Dallman and Lakeside Ash Ponds
Post-Closure Plan
City Water, Light and Power
Springfield, Sangamon County, Illinois

September 23, 2025

1. Responses to Attachment 3 Items

FIGURE NO. 2

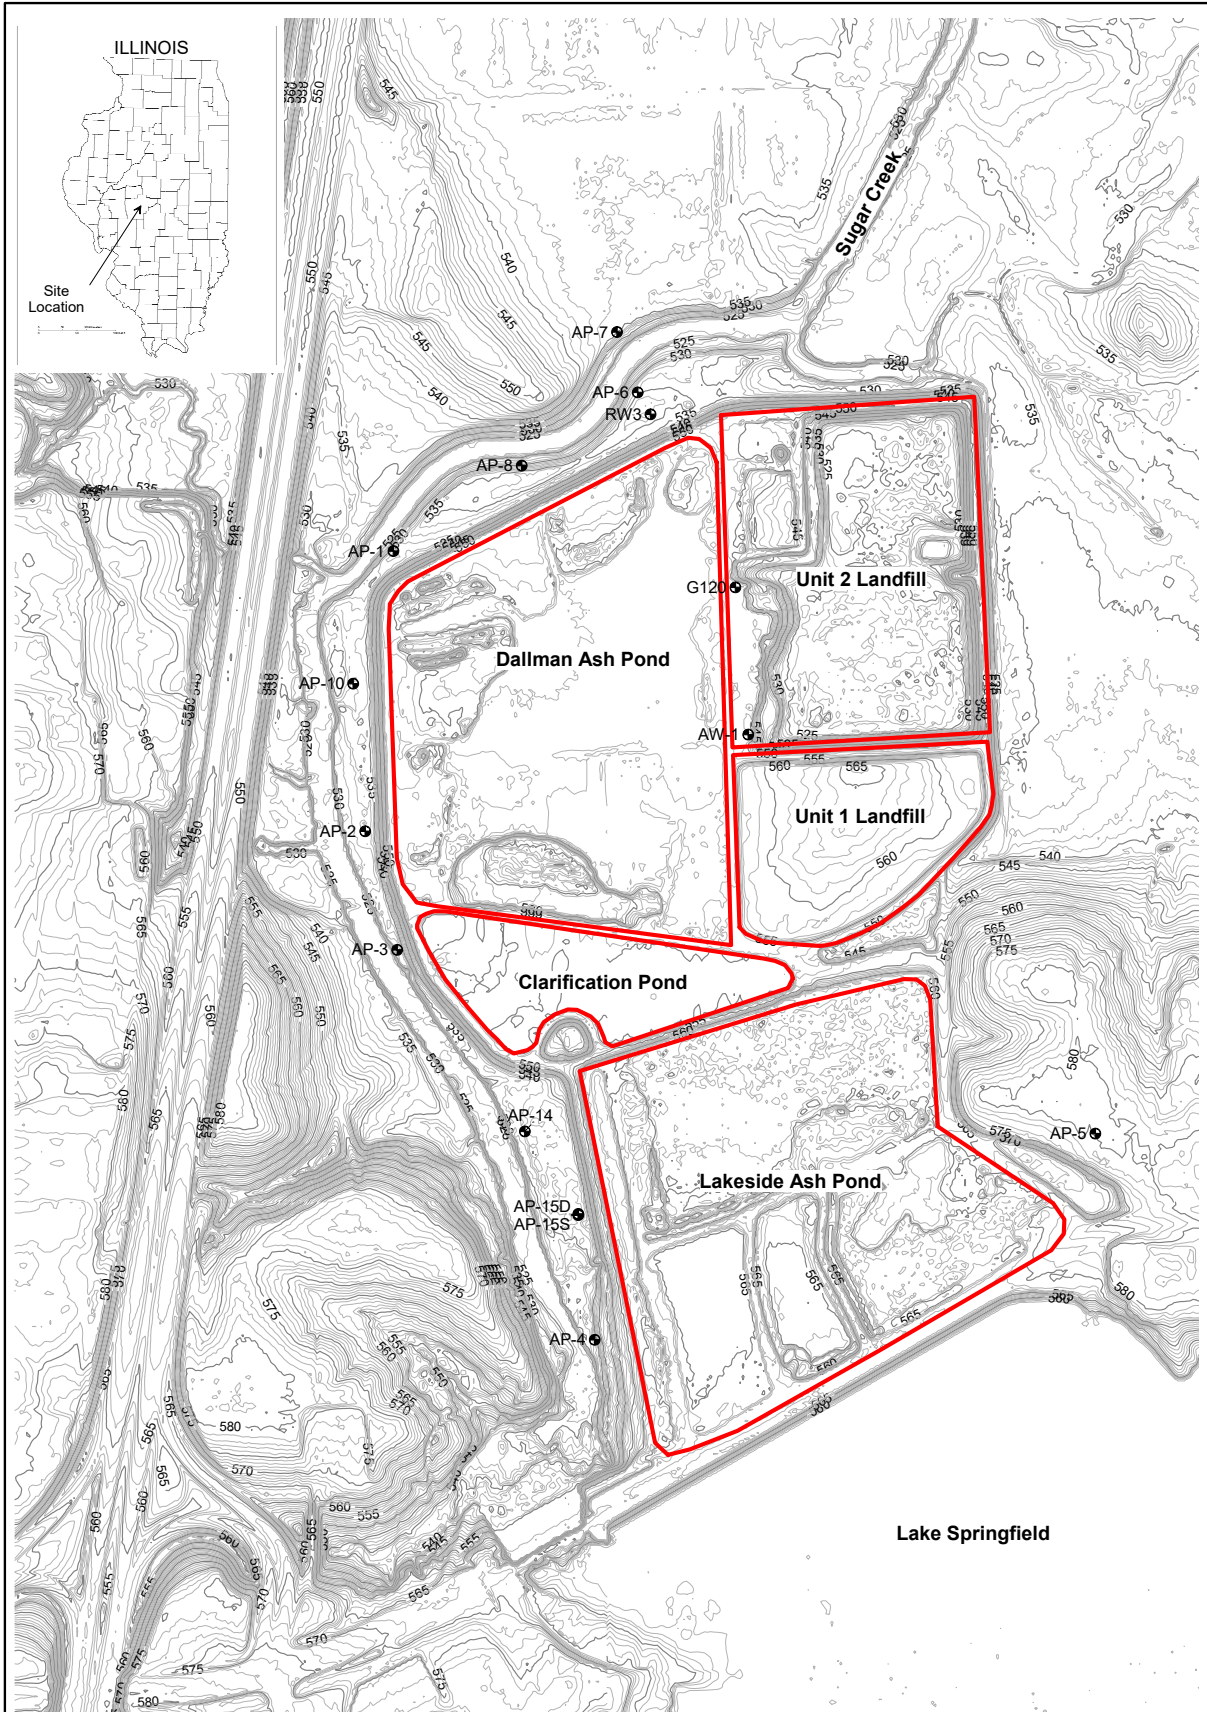
1.1.1 Include the wells identified as part of the Surface Impoundment GWMS from the CAFO.

See Section 4.4 for the monitoring well information and Figure 2 for a location map.

The groundwater monitoring system consists of the following monitoring wells AP-1, AP-2, AP-3, AP-4[†], AP-5[‡], AP-6, AP-7[‡], AP-8, AP-10, AP-14, AP-15D, AP-15S, AW-1, RW-3, and G120. Figure 2 shows the locations of the monitoring wells relative to the impoundments.
